CRITICAL SERVICE BULLETIN

CATEGORY 2**CSB19-01A**

**Supersedes CSB19-01
TECHNICAL PORTIONS
FAA APPROVED**

SUBJECT: Fuel (Primer) Diverter Valve Assembly**PURPOSE:** To assist Owners, Operators, and Maintenance Facilities with instructions to remove the fuel diverter valve assembly and provide available options to the fuel injection system for continued service.**COMPLIANCE:** Within the next 25 hours of engine operation or the next scheduled inspection or engine servicing, whichever occurs first.**MODELS****AFFECTED:** New and rebuilt Continental Aerospace Technologies IO-360-ES; LTSIO-360-E, EB & KB; TSIO-360-E, EB, F, FB, G, GB, KB, LB, MB & SB; TSIO-520-BE and TSIO-550-A, B, C & E aviation gasoline (AvGas) engines.**I. GENERAL INFORMATION**

Figure 1. Fuel Diverter Valve Assembly, typical

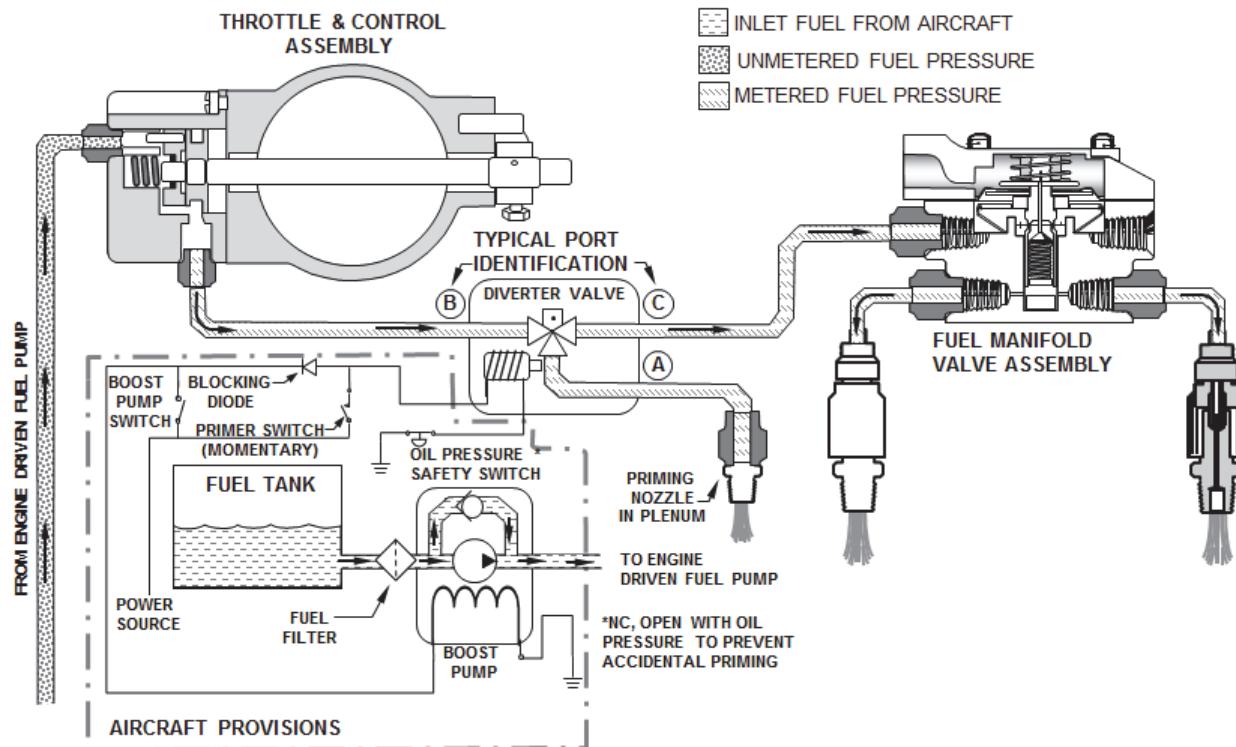
- Verify your cross-flow engine has a fuel diverter valve assembly (P/N 633862, 642199 (14V), 633862-2, or 649268 (28V as shown in Figure 1).

- Remove fuel diverter valve assembly (tubes and connectors) between the throttle and control assembly and fuel manifold valve assembly (see Figure 1, port identification B & C and Figure 2 through Figure 4, example configurations).
- Remove tube/hose assembly, as applicable, (see Figure 1, port identification A and Figure 2) between fuel diverter valve assembly and priming nozzle(s).
- Remove disconnected priming nozzle connector(s) and tube assemblies connected to induction system (location references see Figure 2 and Figure 8).

Figure 2. Fuel Diverter Valve Assembly, TSIO-360-KB

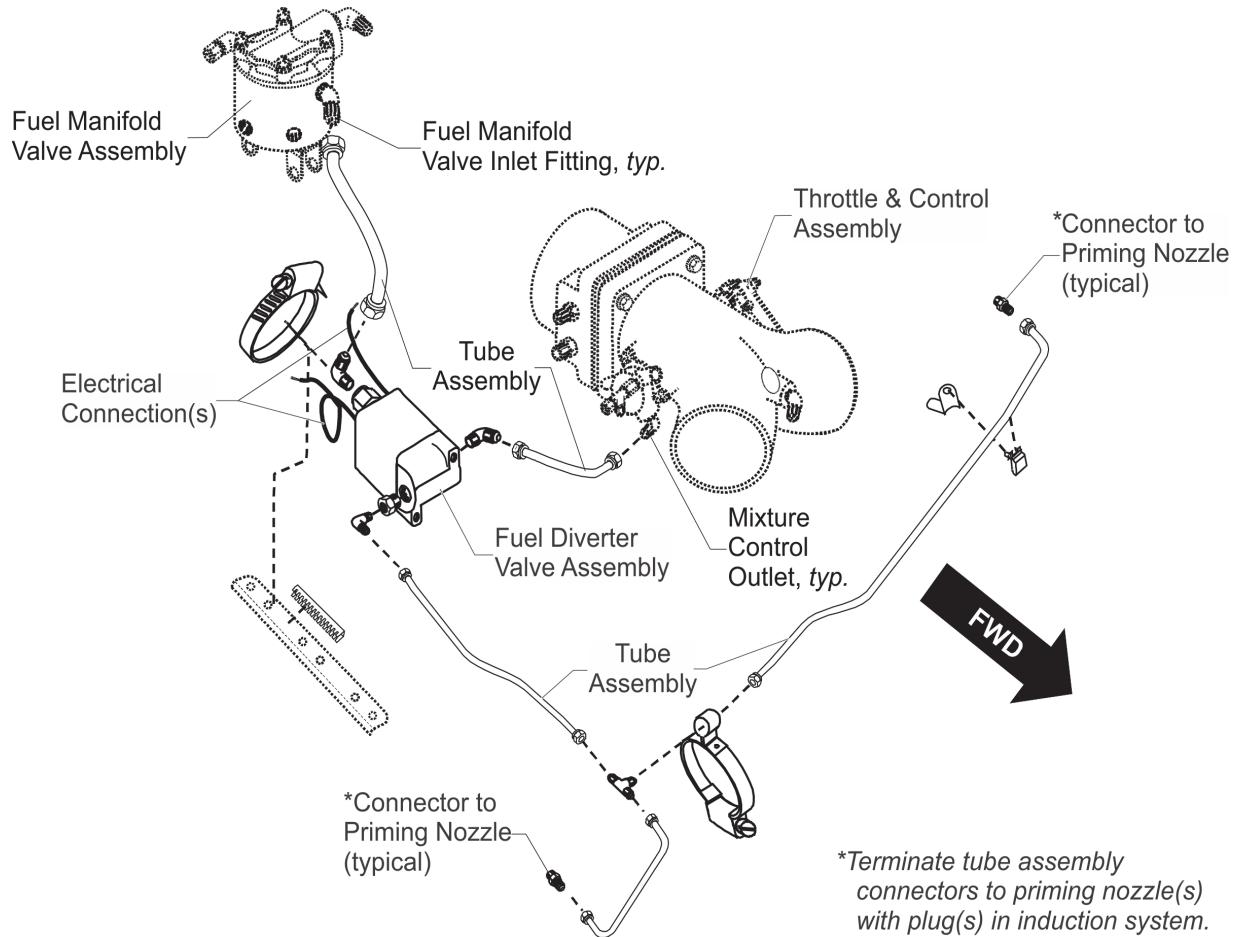
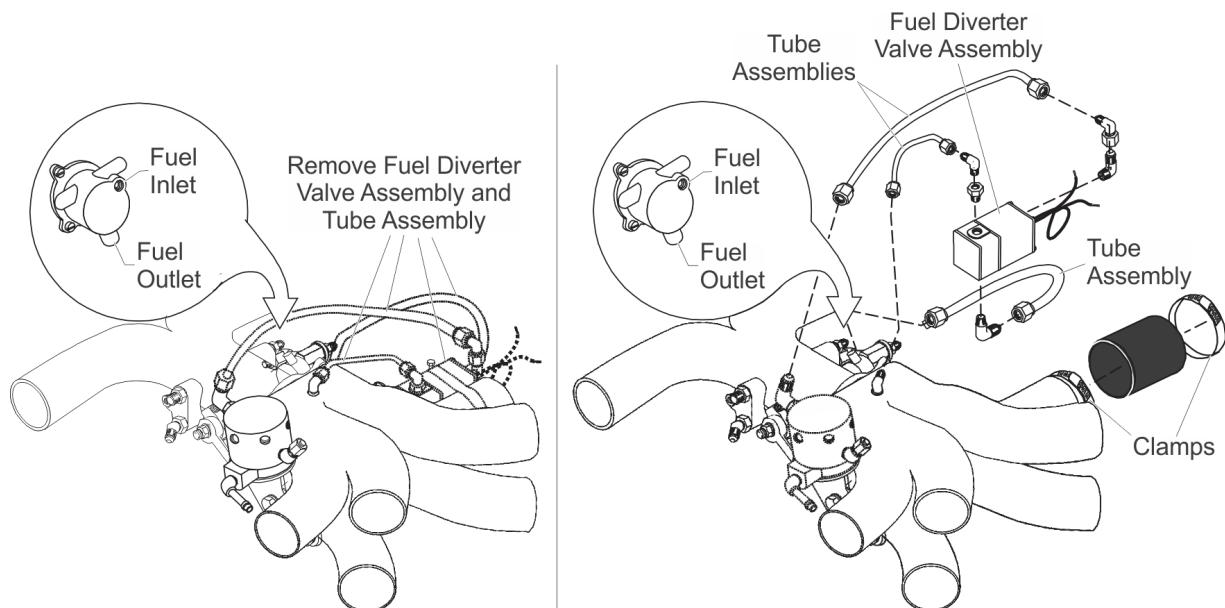
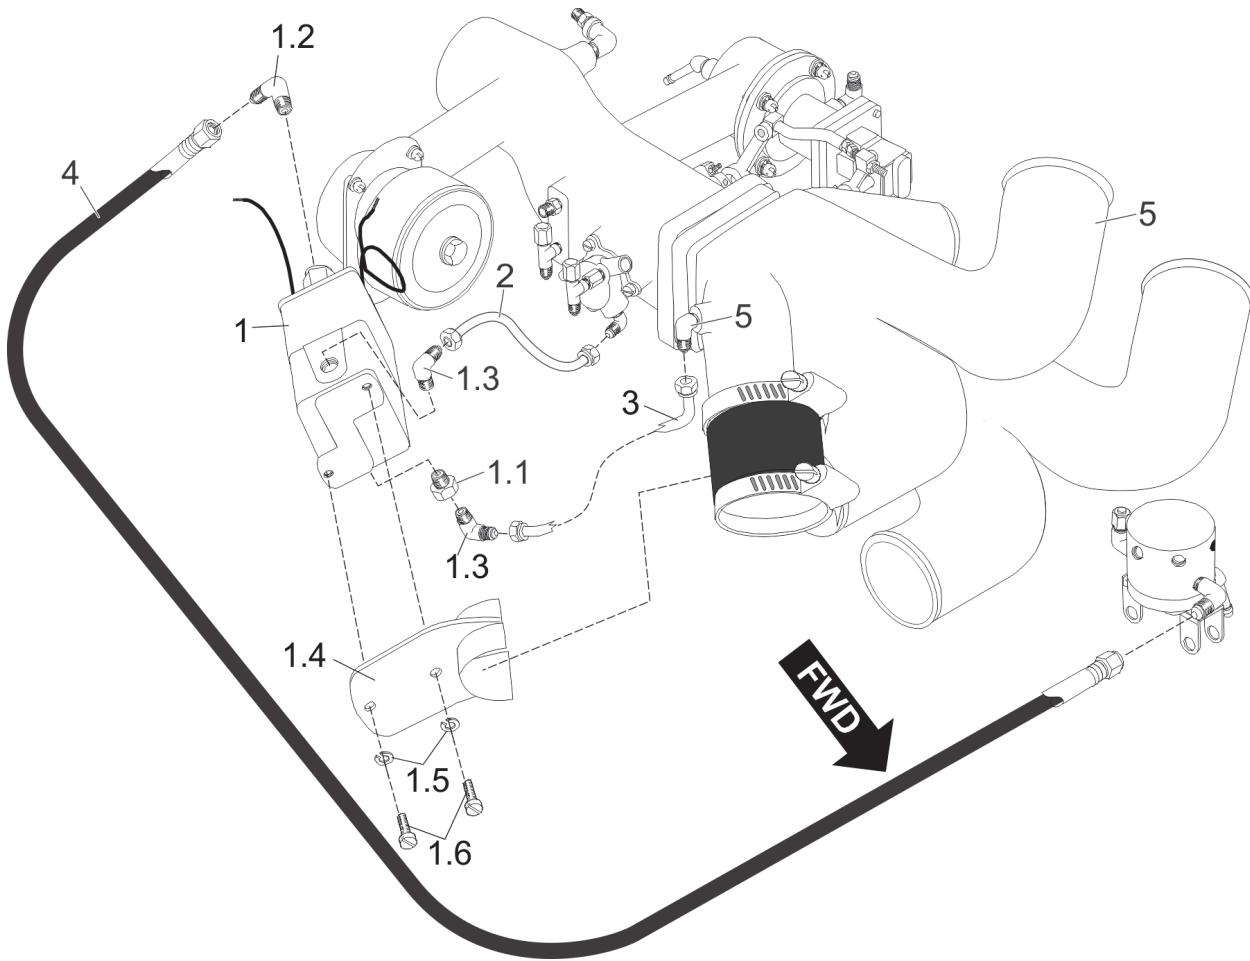
NOTE: Before removing the fuel diverter valve assembly or fuel manifold valve, either take a photograph or draw a sketch of the fuel injection fitting locations, positions, connections, electrical harness and connections for future reference (examples Figure 2 through Figure 4).

Figure 5. Cylinder Drain Connector, location

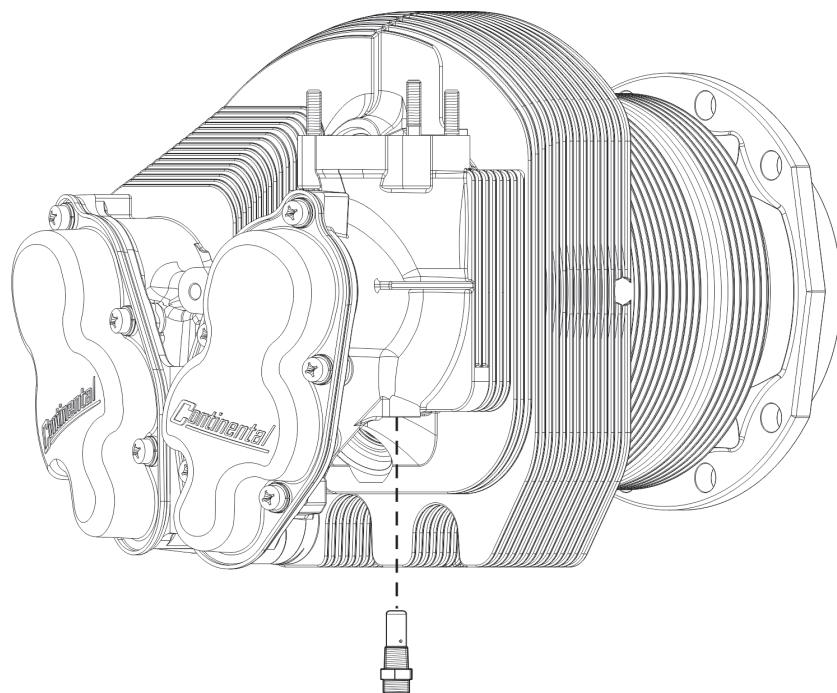
1. Inspect cylinder (see Figure 5) for the current production cylinder drain connector (P/N 655742). The cylinder drain connector can be identified by a 0.060-inch deep punch mark in the wrenching flat (see Figure 6 on page 6, P/N 655742).
 - a. If the cylinder drain is identified as P/N 655742, replacement is not necessary.
 - b. If the cylinder drain cannot be identified, perform an “Induction System Drain Inspection” according to M-0, Standard Practice Maintenance Manual, Section 6. If applicable, remove and replace cylinder drain connector(s) with current P/N 655742 (quantity based on number of engine cylinders).

Figure 7. Hose Installation, IO-360-ES; TSIO-360-MB, SB

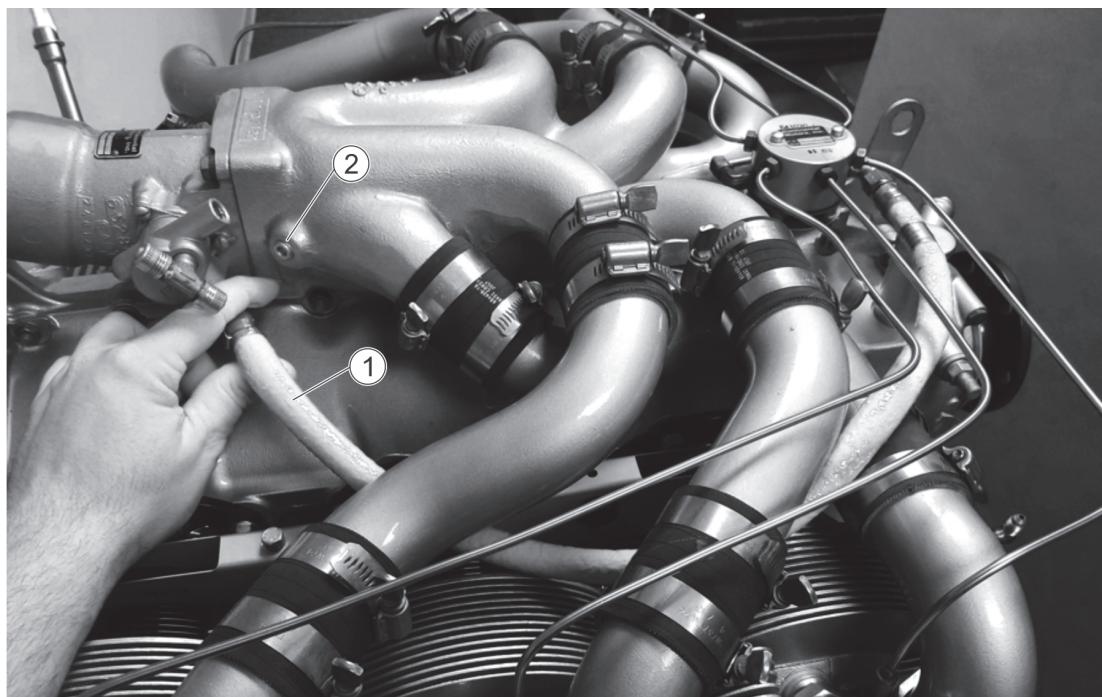
1. Install new hose/tube assembly (reference Table 2 through Table 5 and Figure 7 through Figure 10) between throttle body (mixture control outlet) and fuel manifold valve inlet fitting.
2. Lubricate the hose/tube connector threads with clean 50 weight aviation engine oil.
3. Torque tube or hose fittings to the values specified in the latest revision of M-0, Standard Practice Maintenance Manual, Appendix B.
4. Install plug(s) (reference applicable parts list tables) to terminate induction tube port(s). Lubricate the plug threads with Loctite® 592 PST thread sealant and torque to the values specified in the latest revision of M-0, Standard Practice Maintenance Manual, Appendix B.

Figure 10. Hose and Clamp Assembly, TSIO-520-BE; TSIO-550-A, B, C6B, E

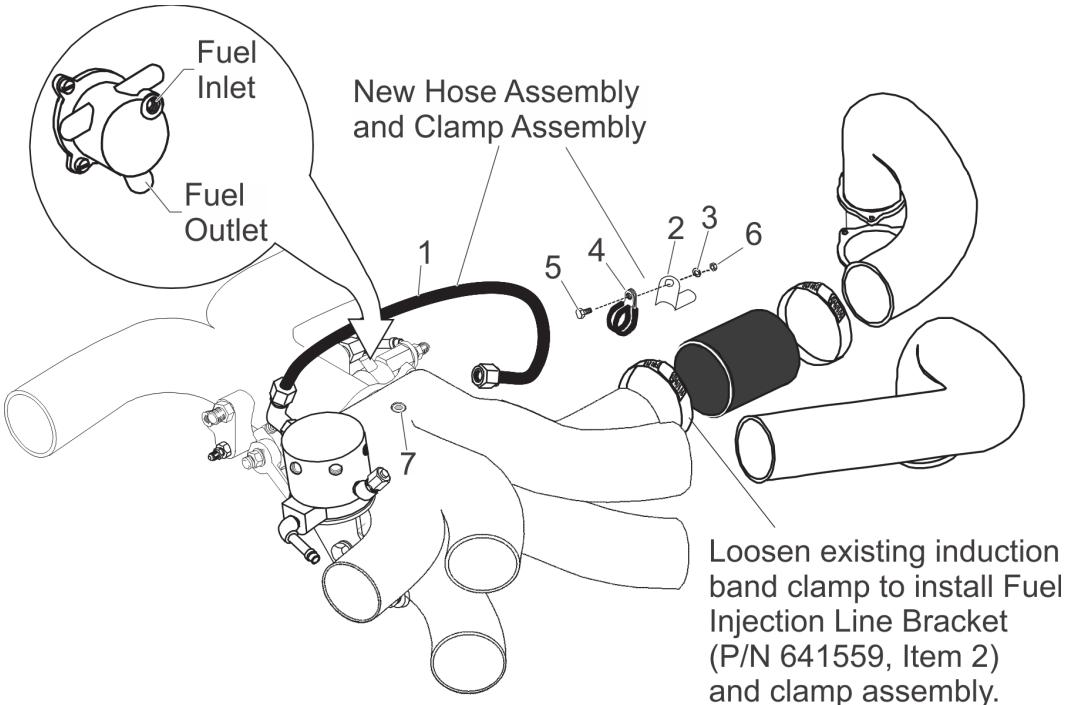
5. Reference Figure 10, to assemble the hose assembly (P/N 646644S6S23.00) and clamp assembly (fuel injection line bracket (item 2) for the TSIO-550-C6B engine. Loosen the induction clamp at the induction joint and insert bracket (item 2) under the induction clamp.
6. Reposition the induction clamp on the induction tube and torque to the values specified in the latest revision of M-0, Standard Practice Maintenance Manual, Appendix B.

NOTE: If the clamp will not tighten or remain torqued to Appendix B specifications, the clamp is unserviceable, replace the induction clamp and perform an “Induction System Inspection” according to instructions in M-0, Standard Practice Maintenance Manual, Section 6-4.
